PCN no.: **PCN_148 rev. 1.0**

Device affected: **nRF52840-QIAA**

Description of change:

Introduction of Amkor Technology Philippines (also referred to as Amkor-Philippines on this document) as additional Assembly and Final Test site. Currently, the product is being assembled and tested at ASE-ChungLi.

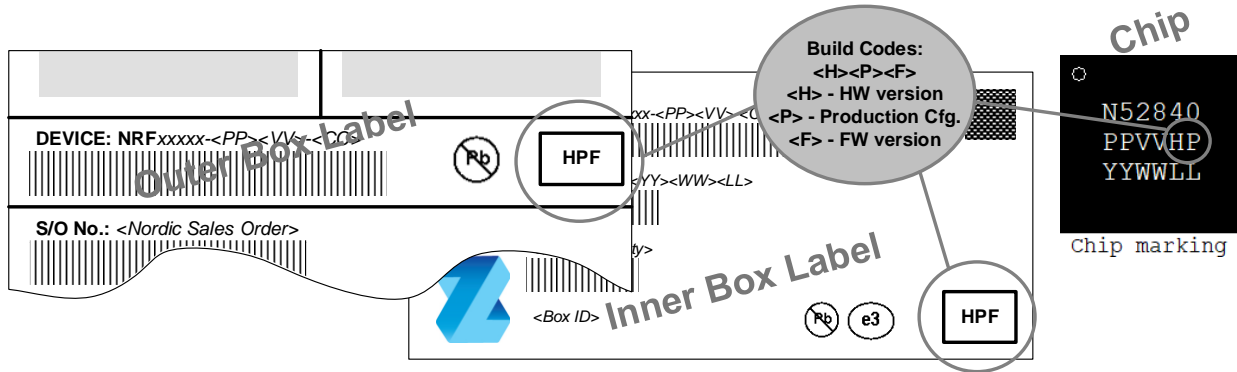
Impact to Fit

Stand-off dimension, A1 for build code D10 is slightly different, minimum value is zero, compared to D00 at 0.02mm.

Stand-off, A1 (mm)	
	D00	D10
Min.	0.02	0
Nom.	0.05	0.02
Max	0.08	0.05

The mechanical specification on the Product Specification of nRF52840 product will be revised to incorporate D10 dimensions.
